# City of Southaven Office of Planning and Development Design Review Staff Report

Date of Hearing:	April 24, 2023
Public Hearing Body:	Planning Commission
Applicant:	Pediatric Dental Group & Orthodontics c/o Patrick Haralson 1365 S Germantown Road Germantown, TN 38138
Total Acreage:	1.54 acres
Existing Zone:	Planned Unit Development (Silo Square)
Location of Design Review Application	West of Market Square Avenue, north of Front Street
Comprehensive Plan Designation:	Office

# Design Review Documents for the Southaven, Mississippi Planning Commission

# PDGO Pediatric Dental Group Silo Square, Lot 36 Southaven MS

LANDSCAPE PLAN

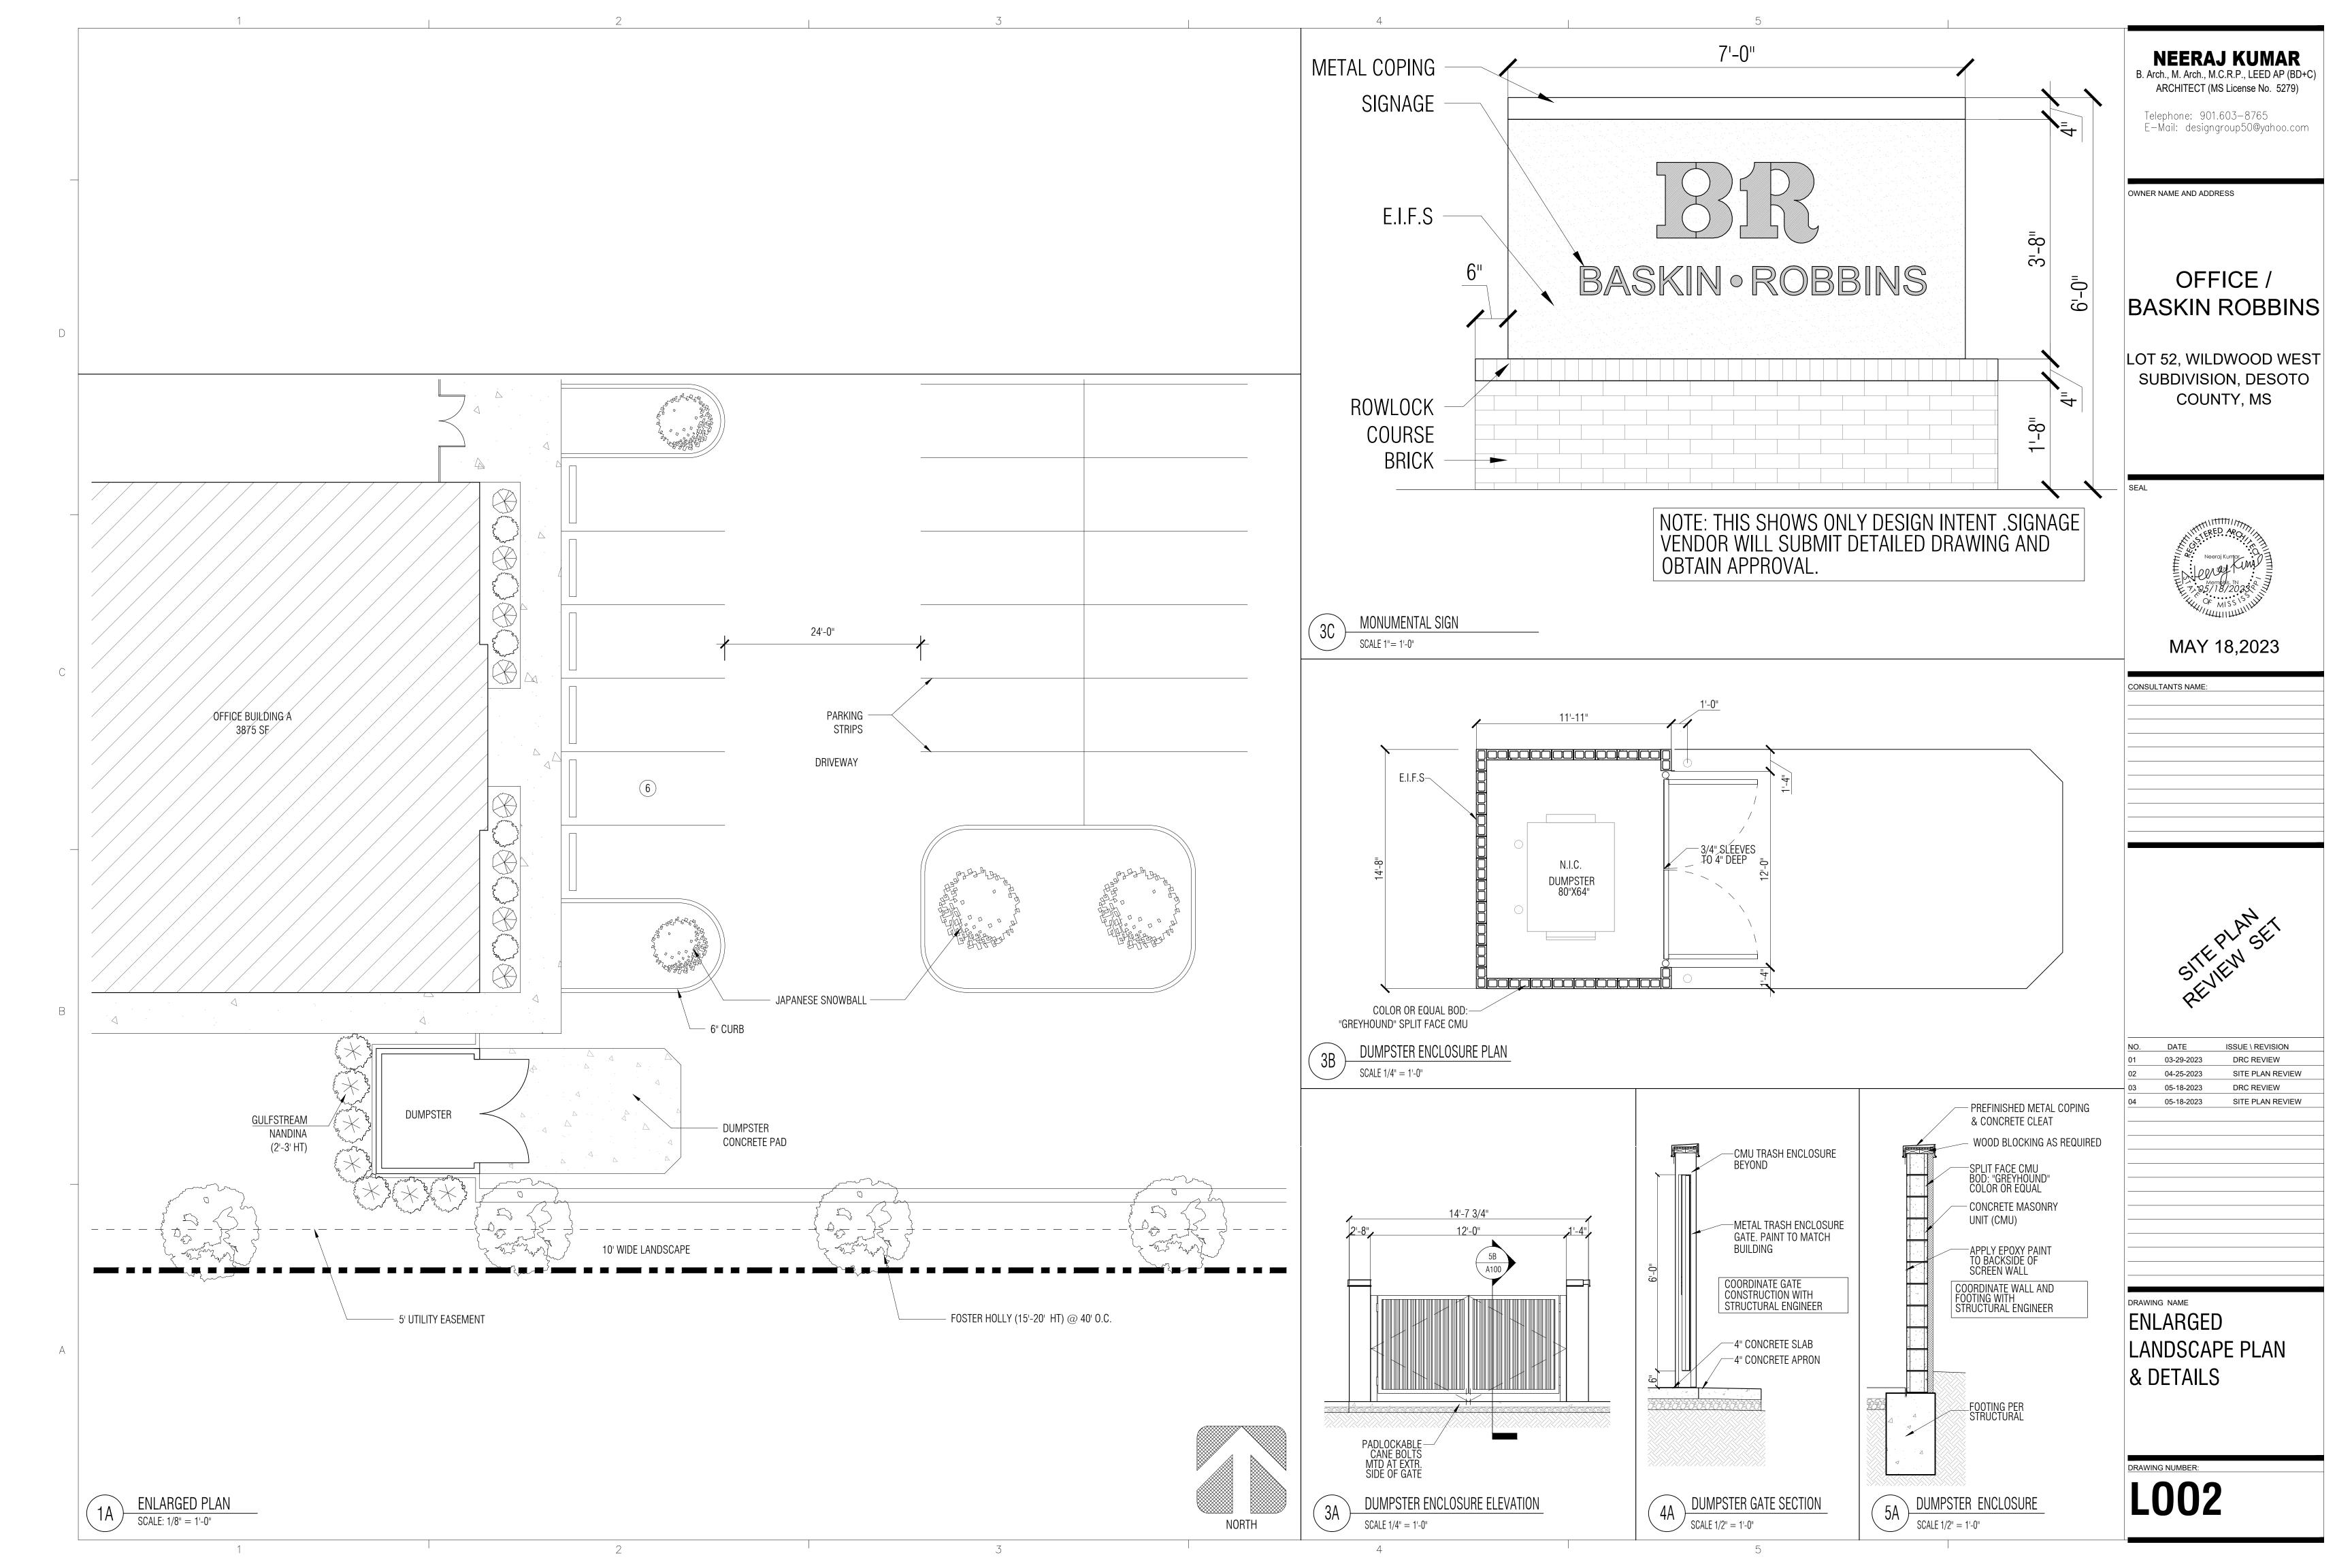
- 3. The landscaping shown provides a good mixture and design; however the applicant has not identified any shade tree species. Since staff is requesting a revision for the west side of the site which allows for more green space, it would be staff suggestion to incorporate some maples to provide a bright fall color into the area along Forrest Bend and along the rear of the site. Staff would request that the plant sizes be adjusted to meet the requirements set forth in the ordinance which require shade trees at 3-3.5", ornamental at 2-2.5" and shrubs at 5 gallon minimums.

LANDSCAPE PLAN

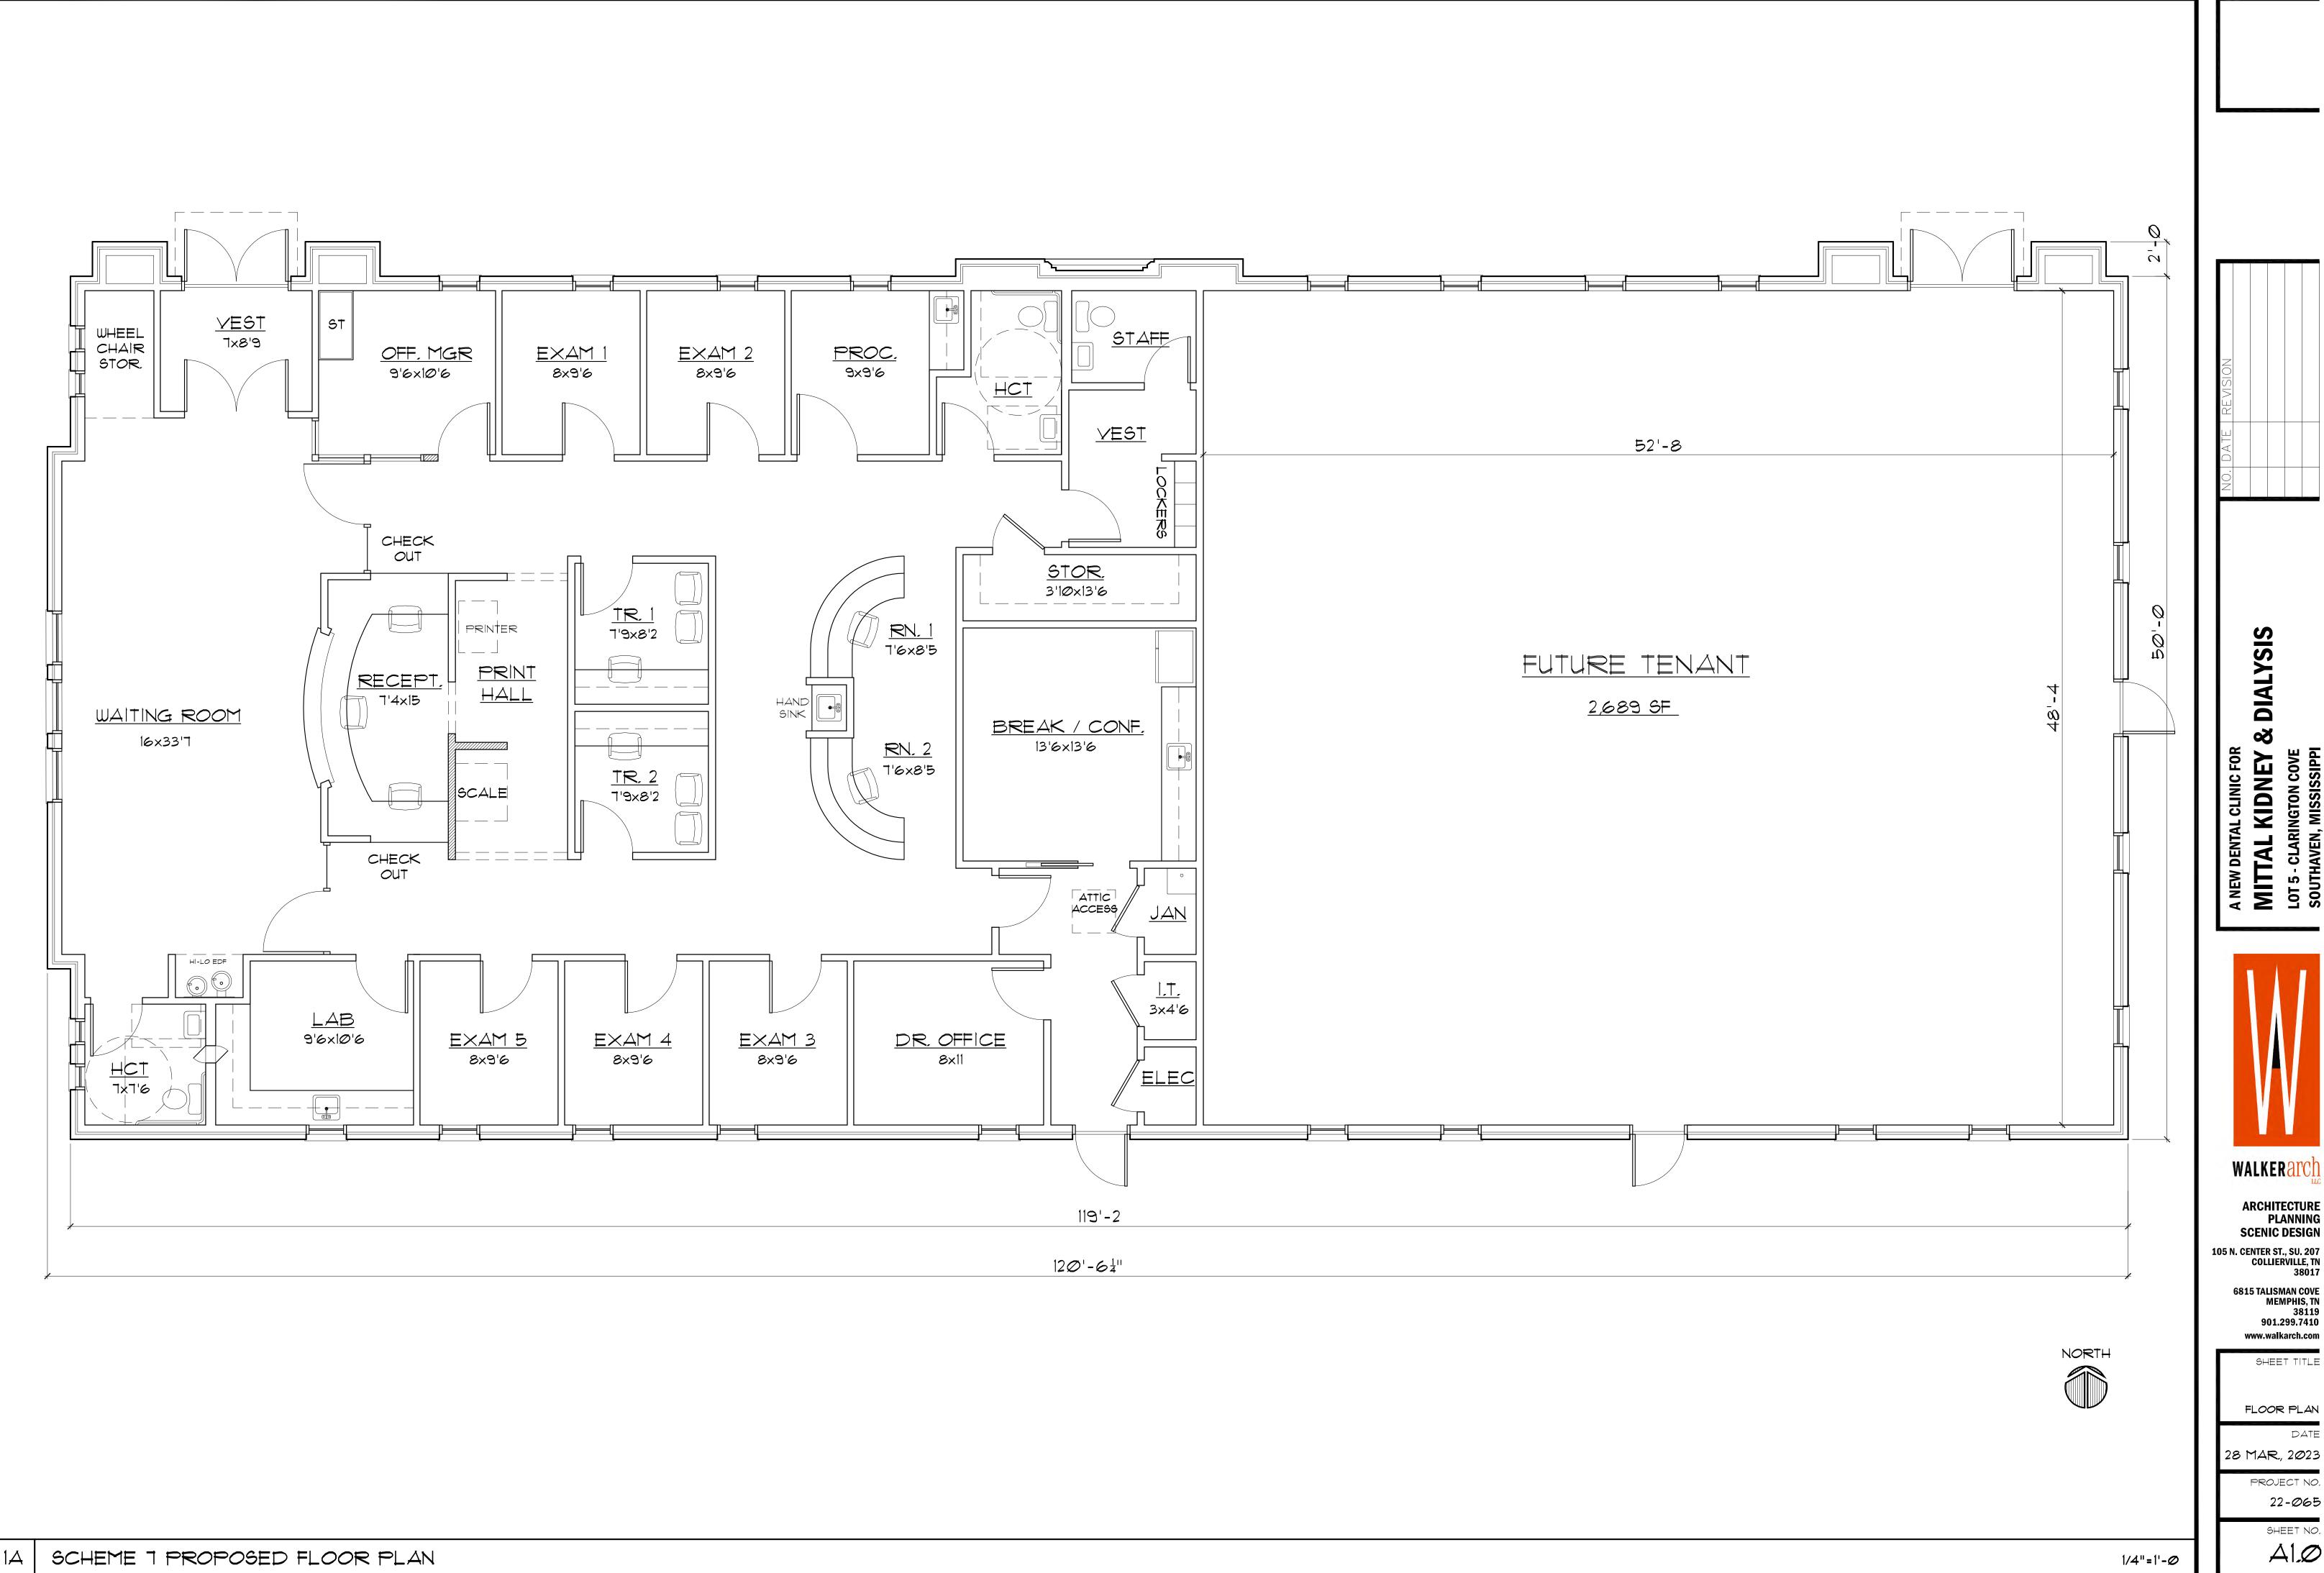
The landscaping proposed is a good mixture with the proper sizing per city ordinance. The only comments staff has would be that:

- 1. The shrubs around the dumpster enclosure should be replaced with evergreen ornamental trees to provide the height and width for screening;
- 2. There should be a masonry wall with shrubs around the ground mounted equipment for screening purposes.
